Commonwealth Edison Company  
Byron/Braidwood Units 1 and 2  
Relaxation of MSSV Setpoint Tolerance to +/-3% - Revised SECL

Enclosed please find Revision 1 to safety evaluation SECL 90-469, previously transmitted via Reference 1. The revised safety evaluation clarifies the section of the ASME code associated with the main steam safety valves.

WESTINGHOUSE NUCLEAR SAFETY  
SAFETY EVALUATION CHECK LIST

APPENDIX B  
UFSAR MARKUPS

**FIGURE 15.2-8**

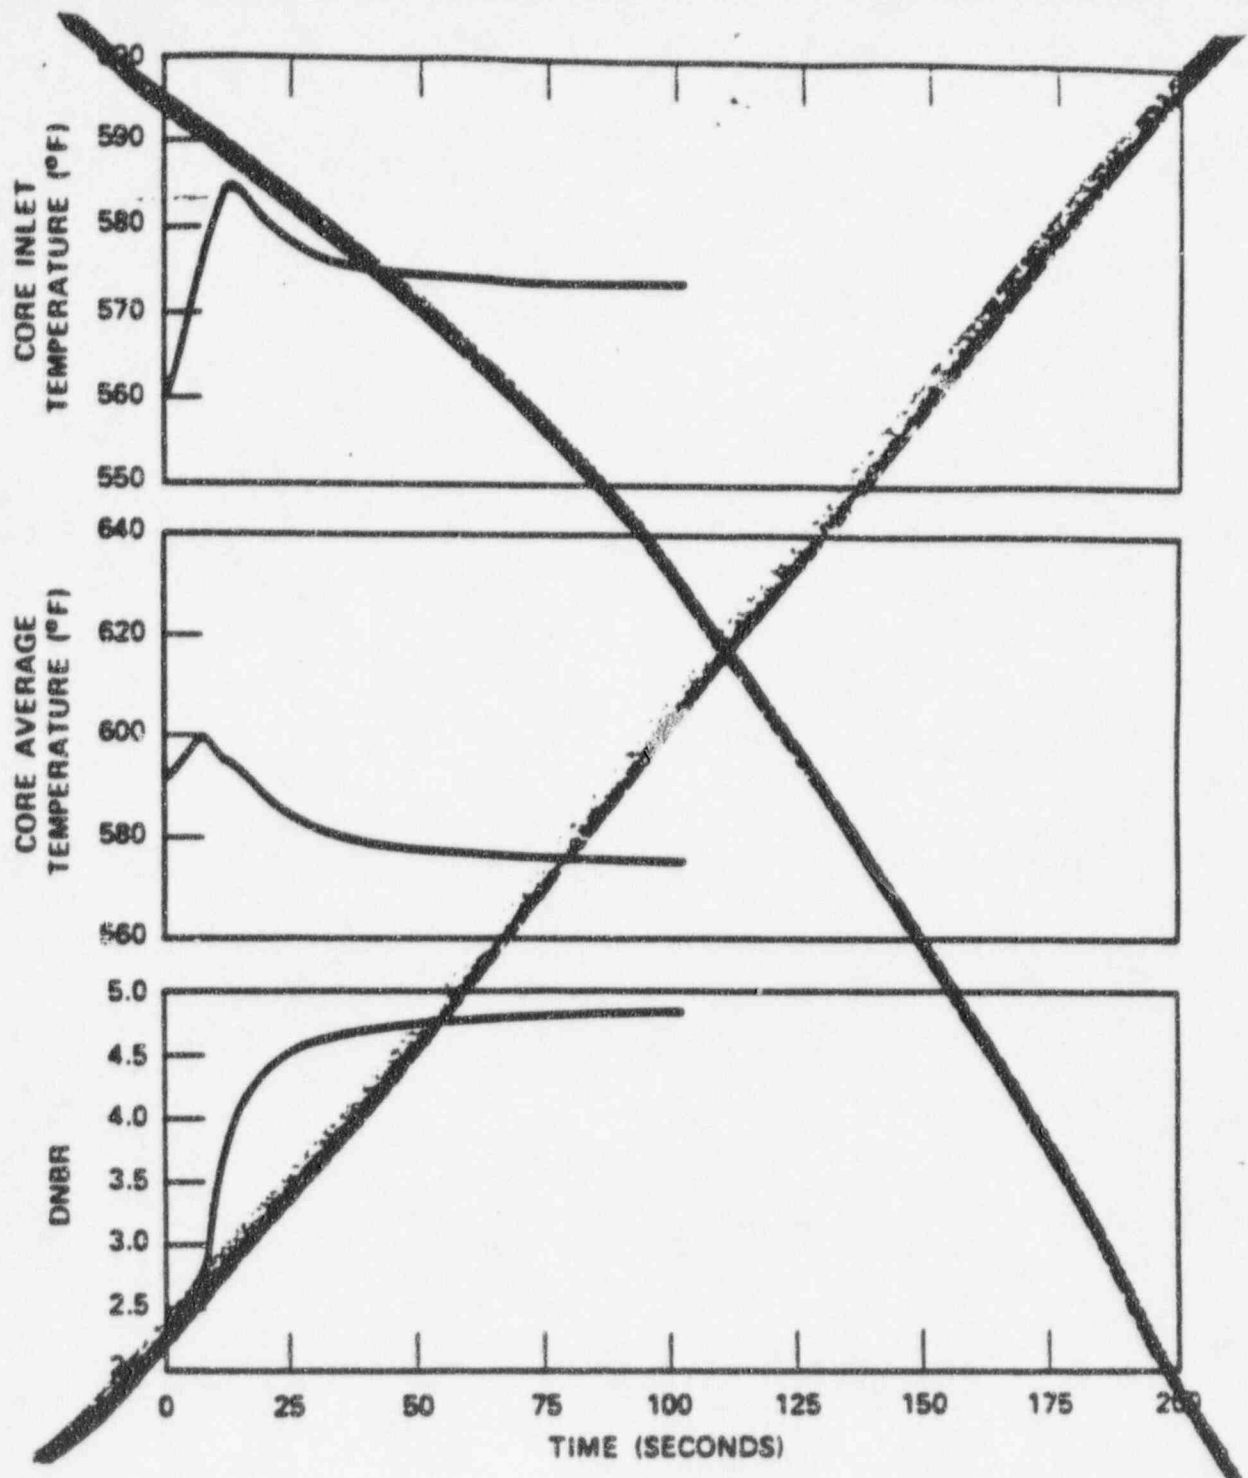
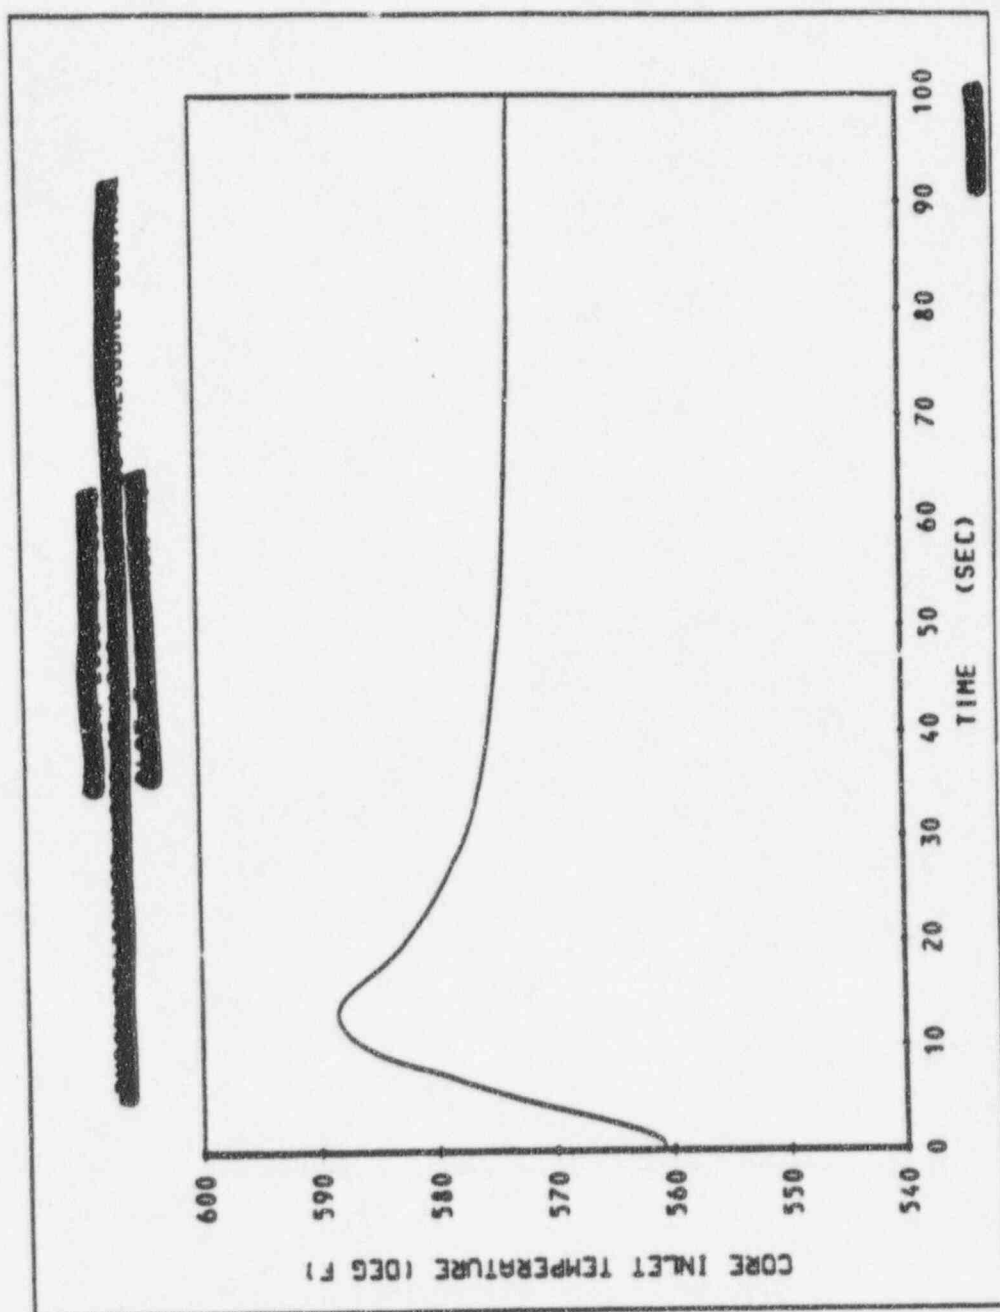
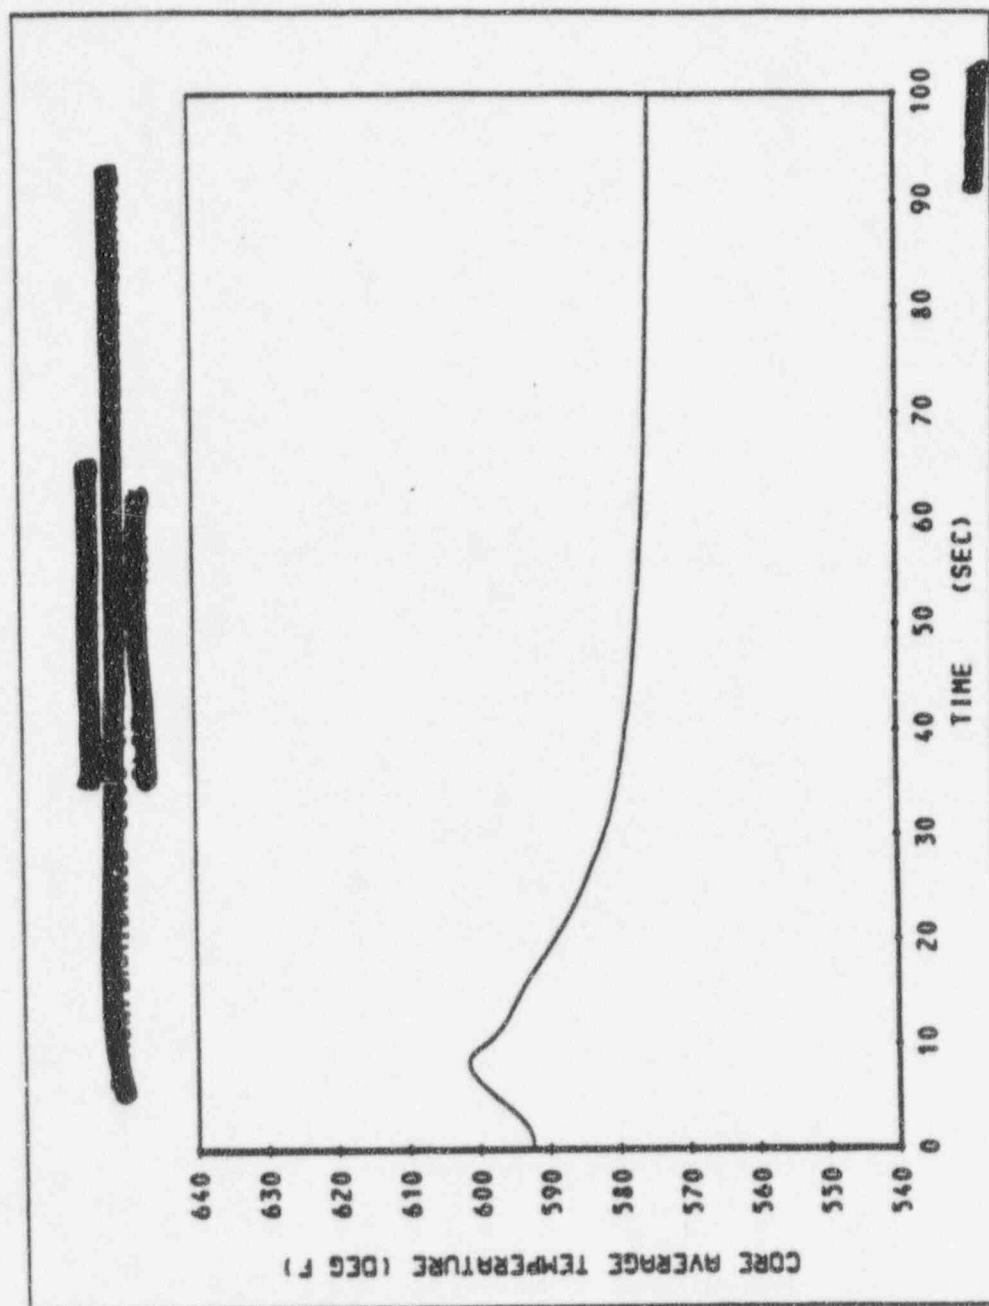
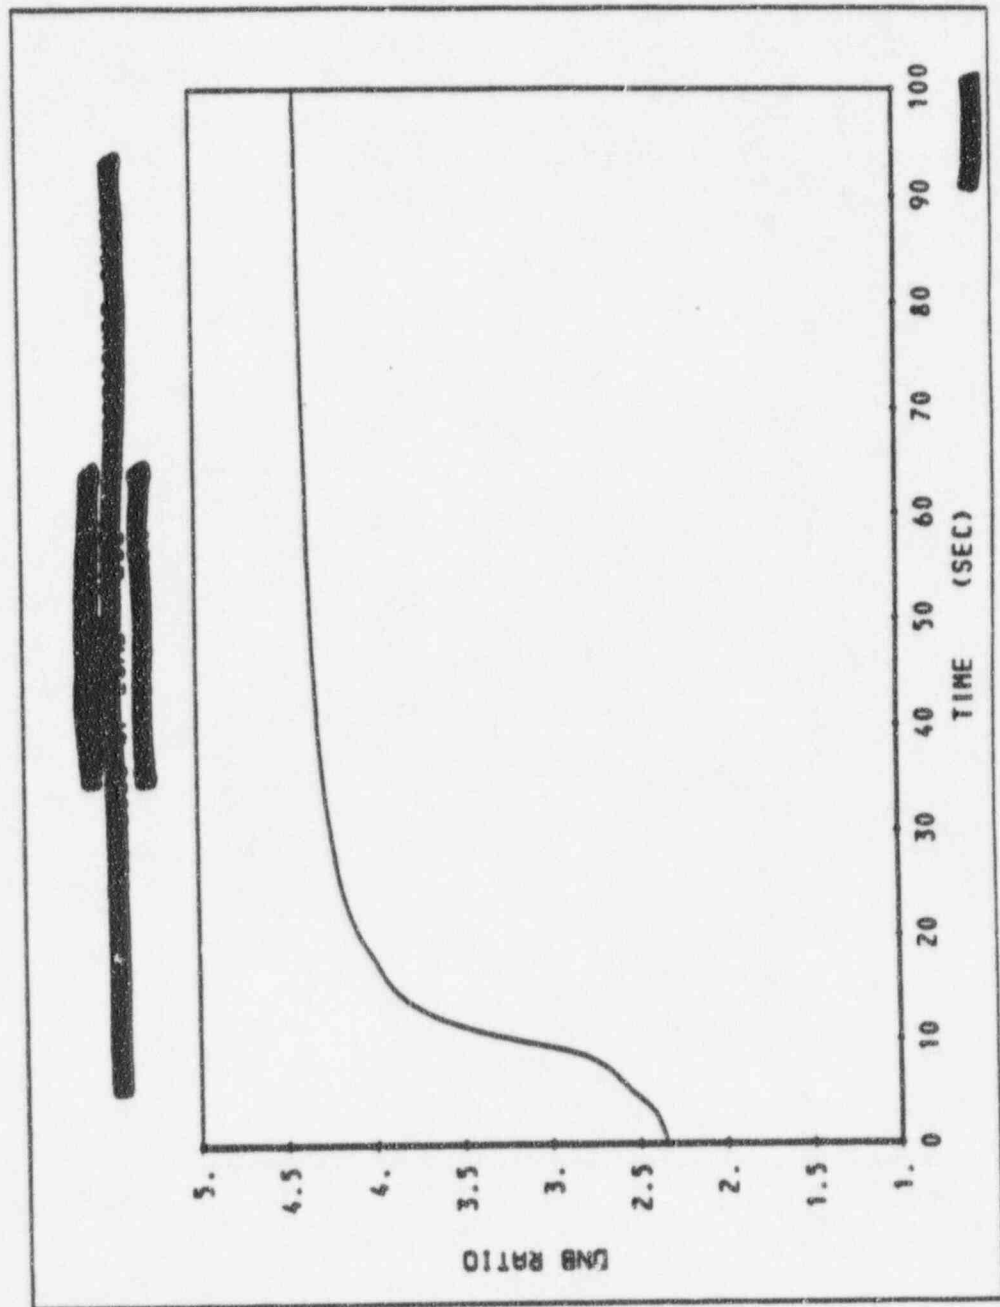
REPLACE WITH  
The following  
Figures
